# Roadway Plans\_V1.pdf Markup Summary

# CONSTRUCTION PLANS

CLEARWAY FILING NO. 2, LOT 5		TITLE SHEET	
PROJECT NO. 44-042A		DATE: 06-02-2022	
DESIGNED BY: DIM		SCALE: HORIZONTAL: N/A	
DRAWN BY: CLP		VERTICAL: N/A	
CHECKED BY: DIM		SHEET 1 OF 15	
TS01

**STORM 2  
STA 1+00.00 TO STA 4+38.81**

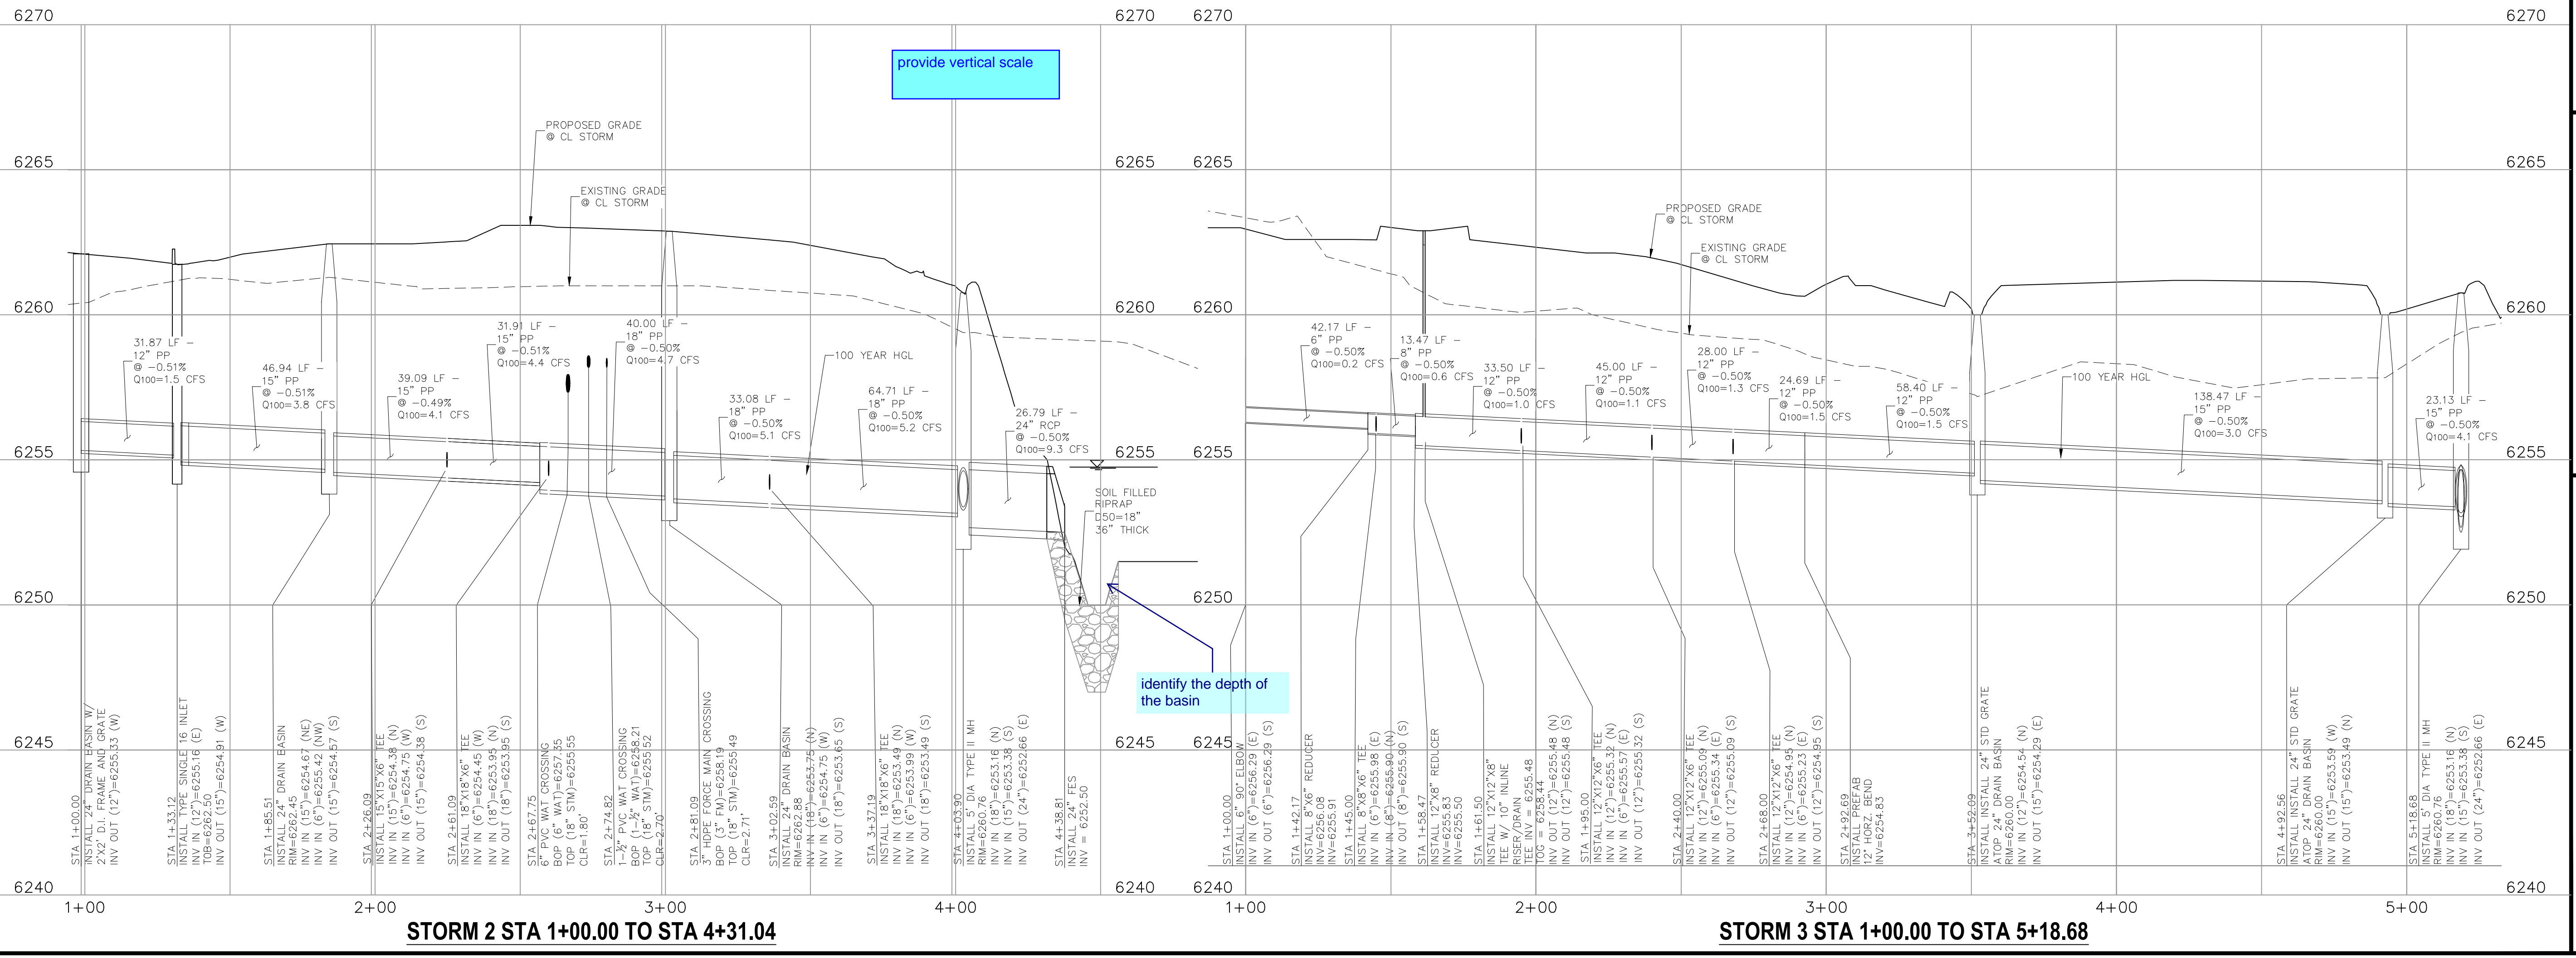
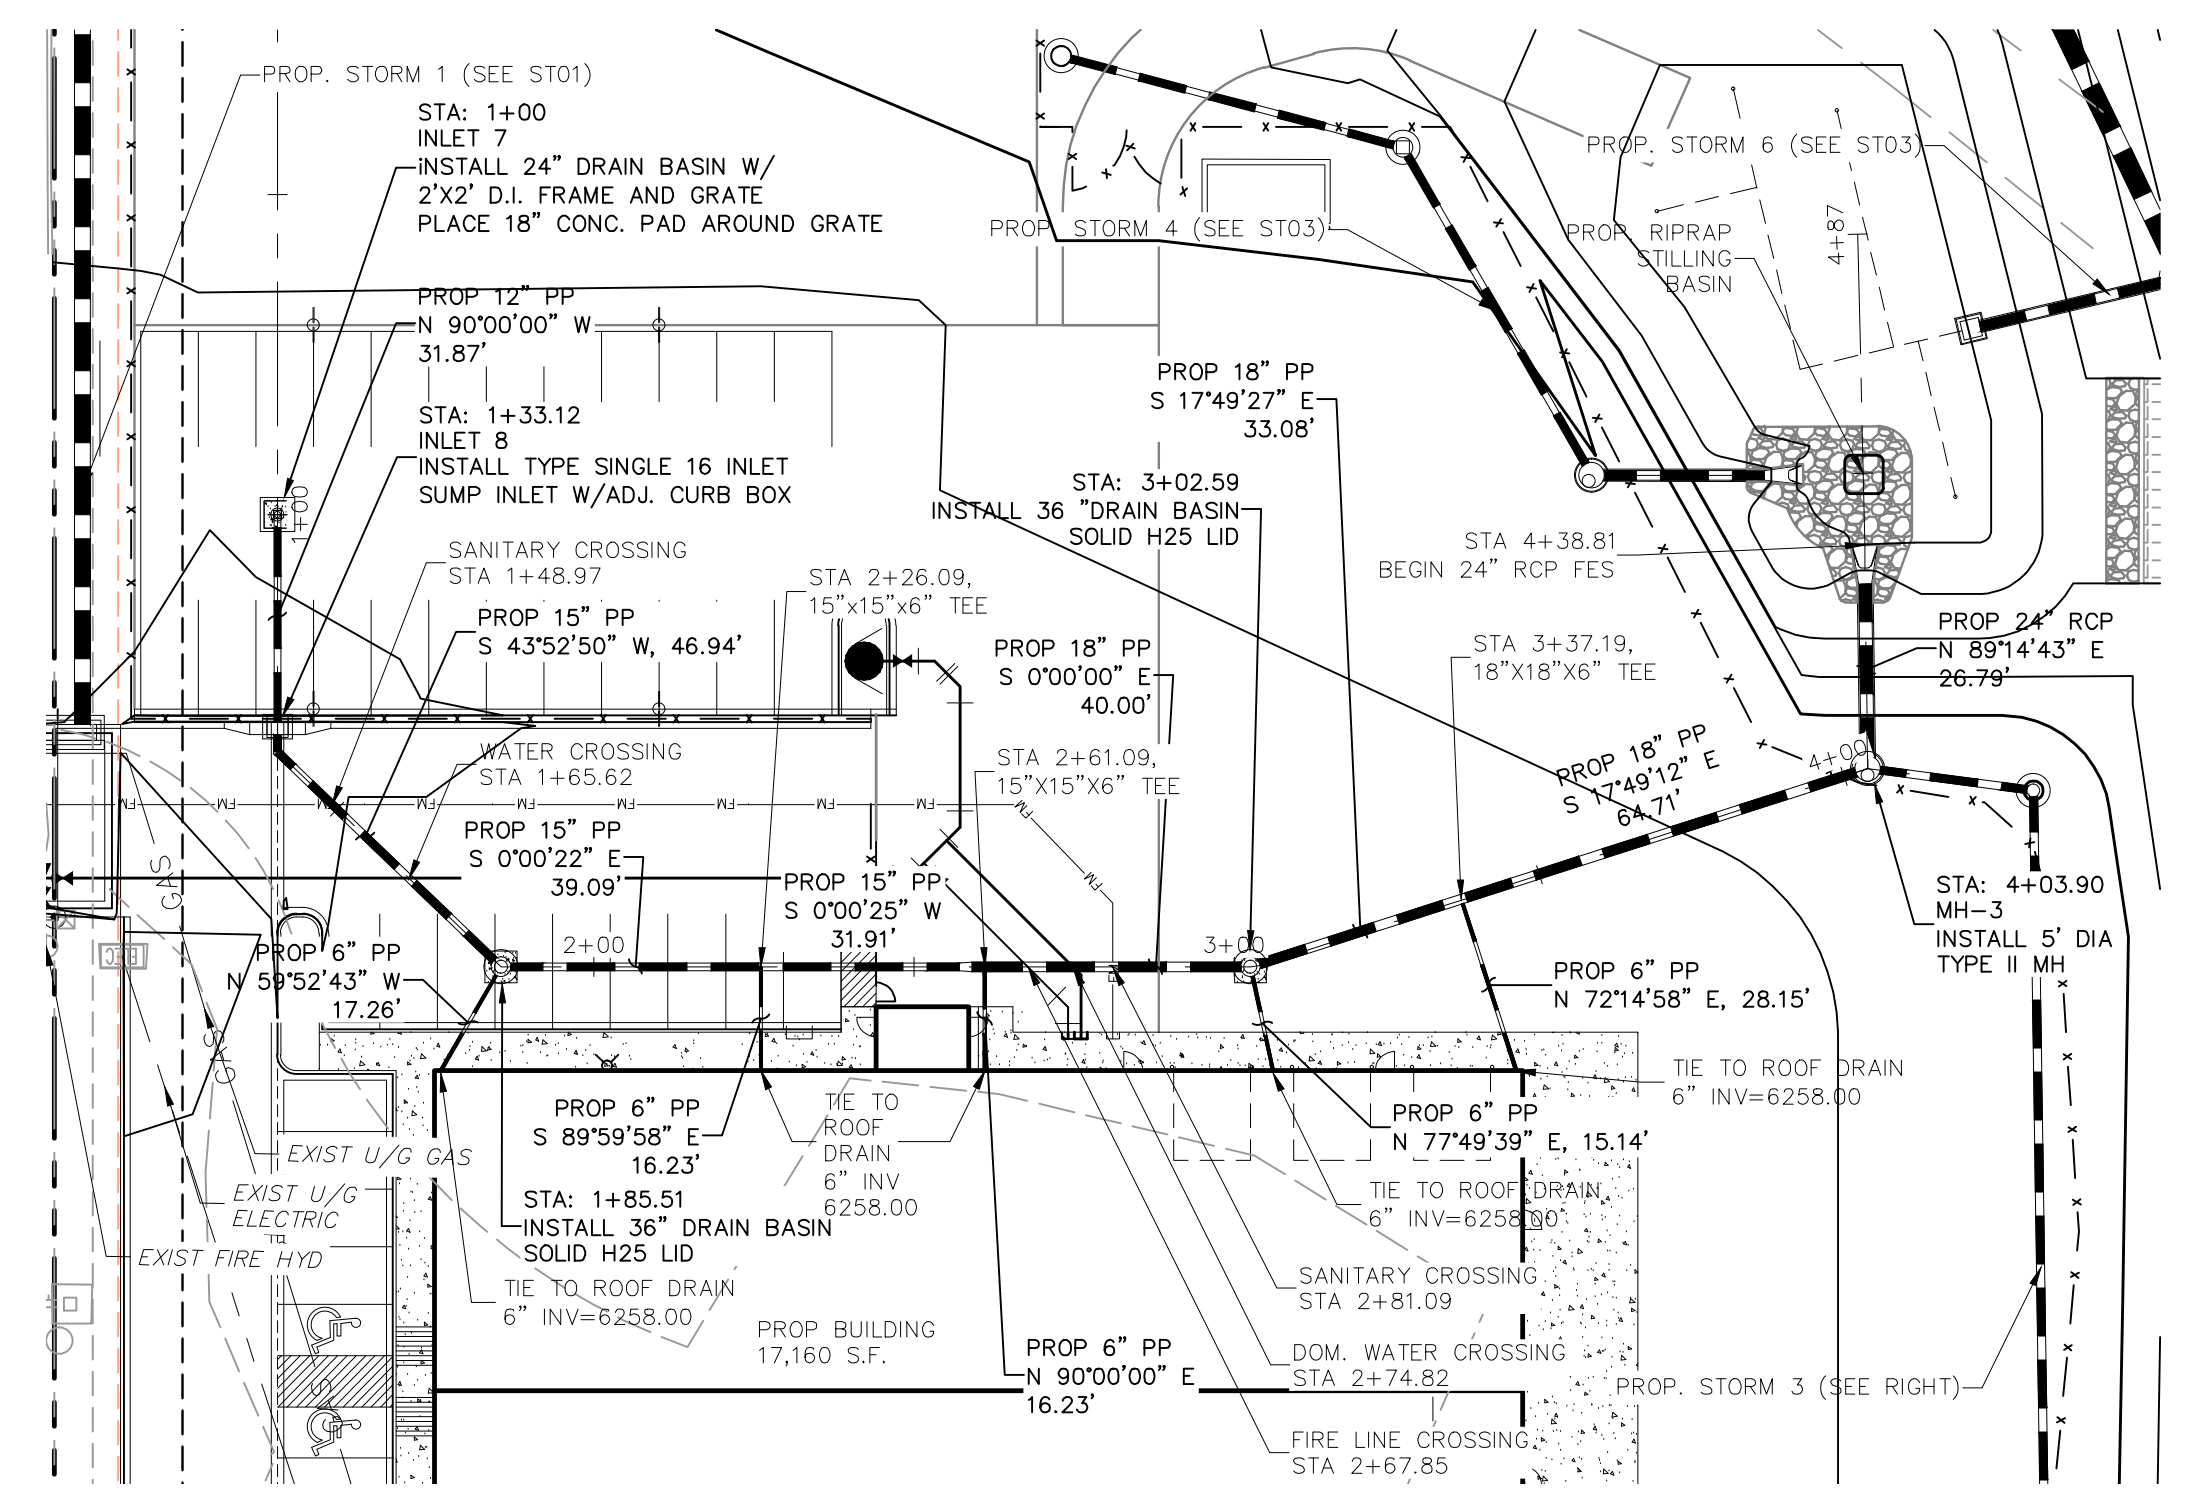
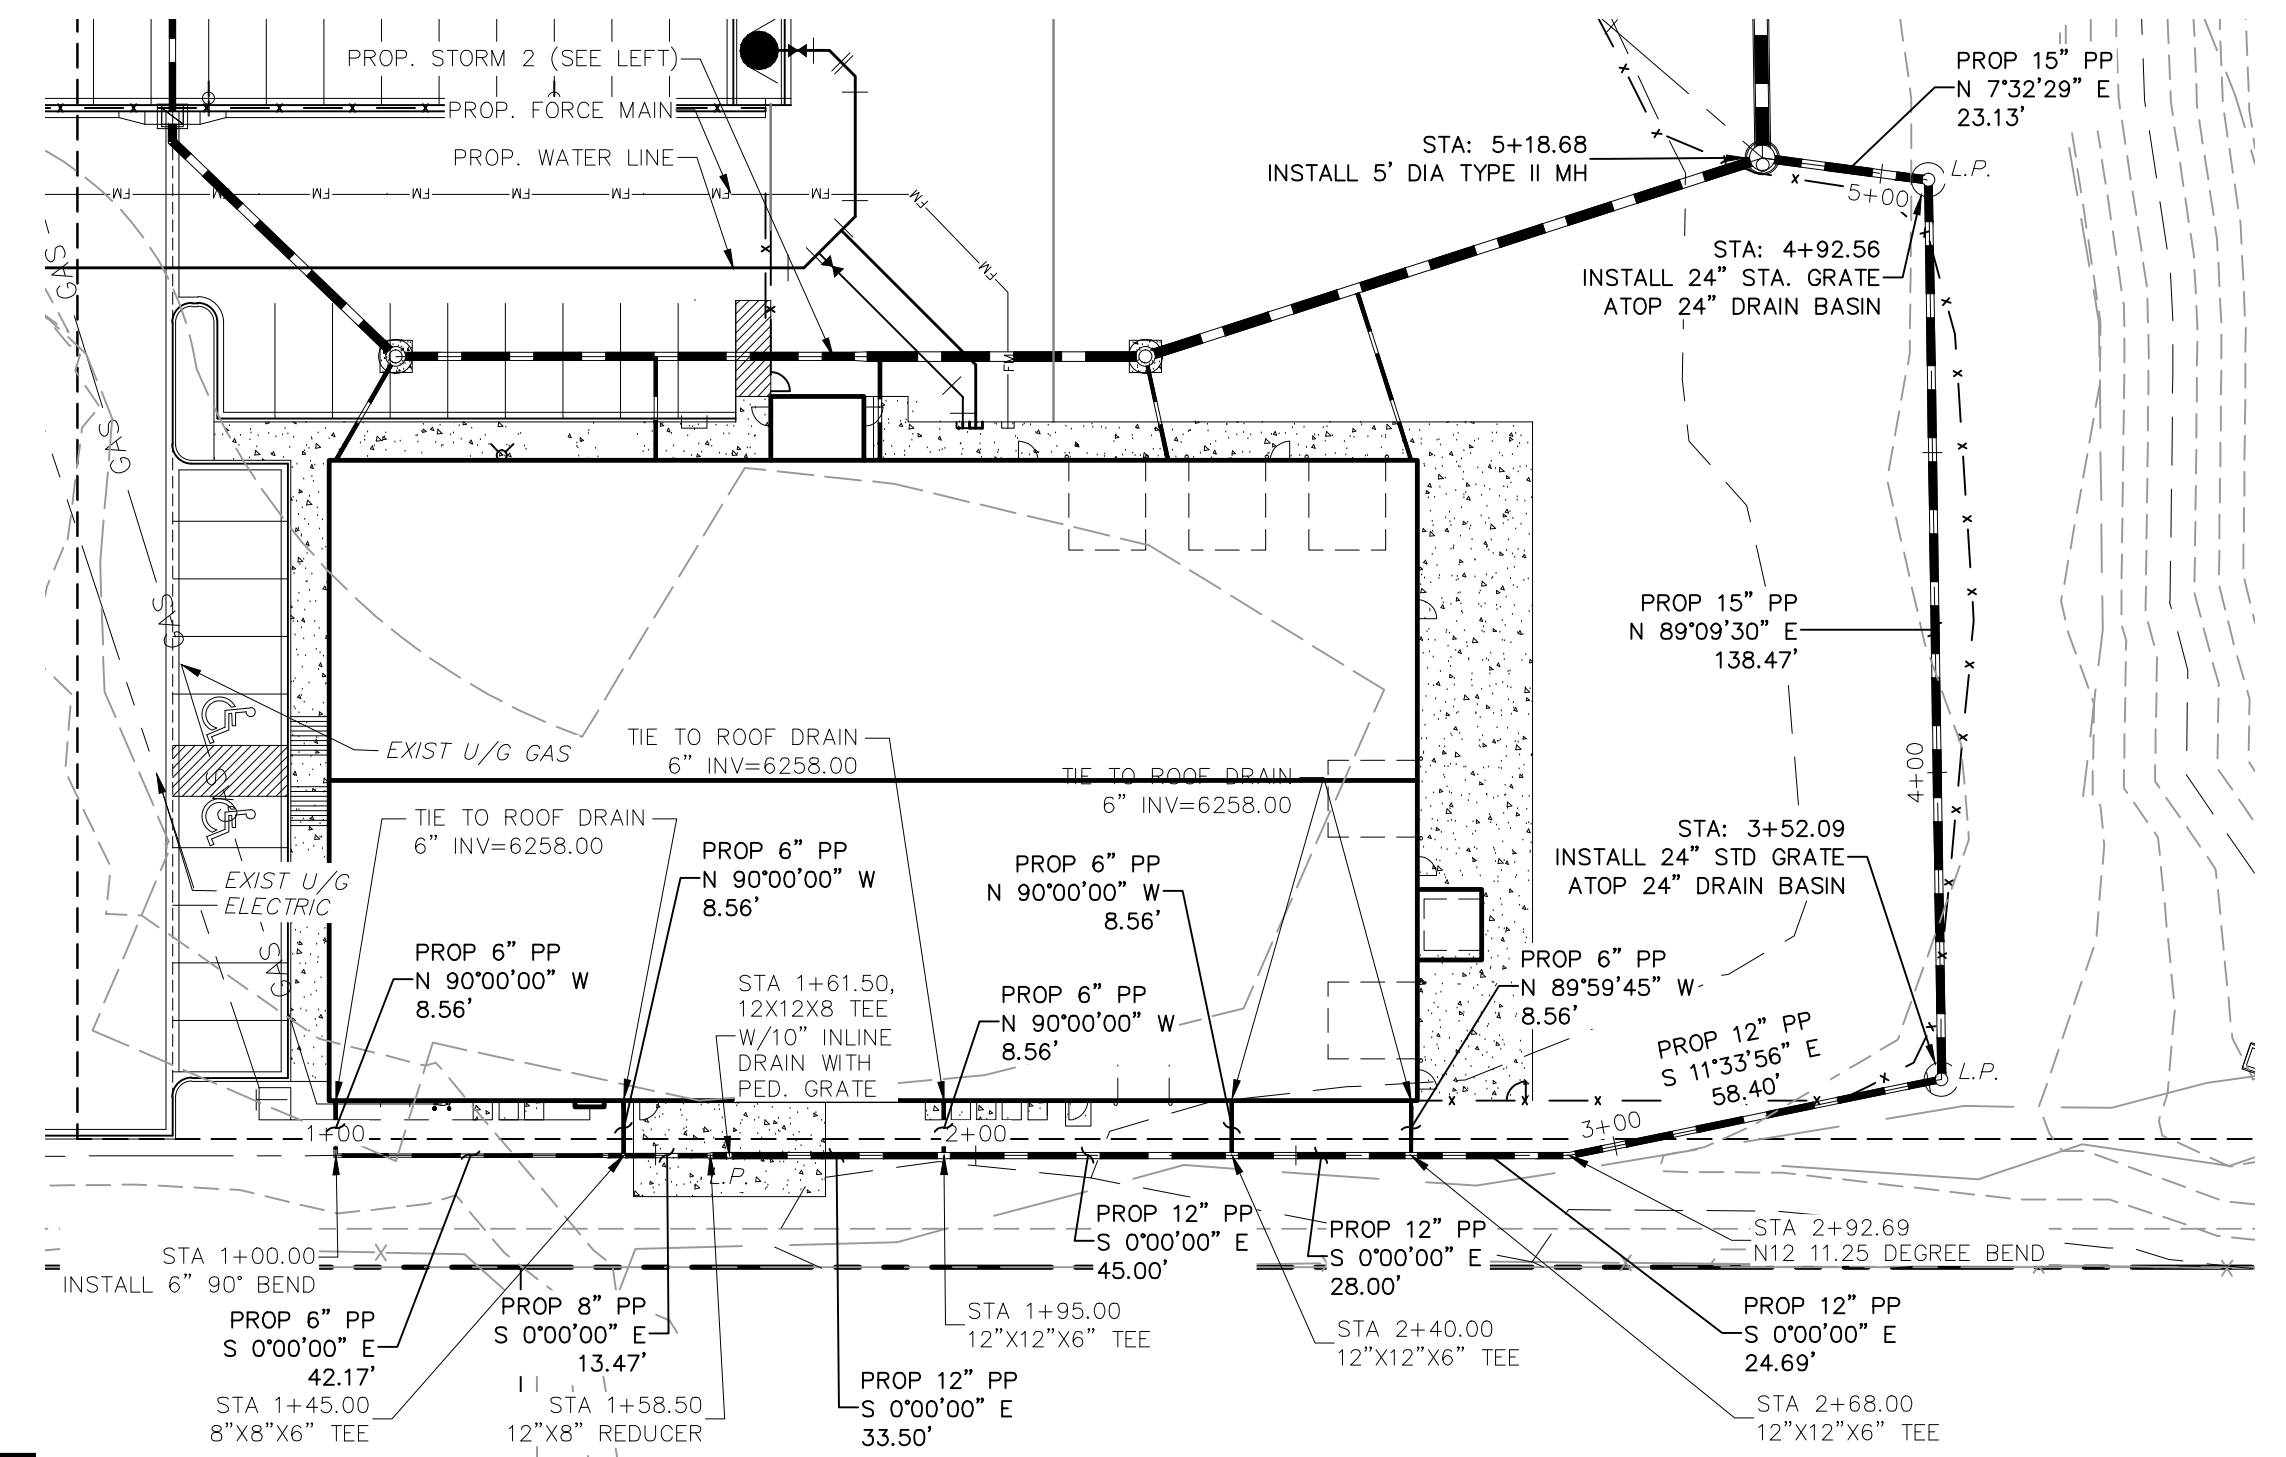
Show HGL lines on the profiles.

provide vertical scale
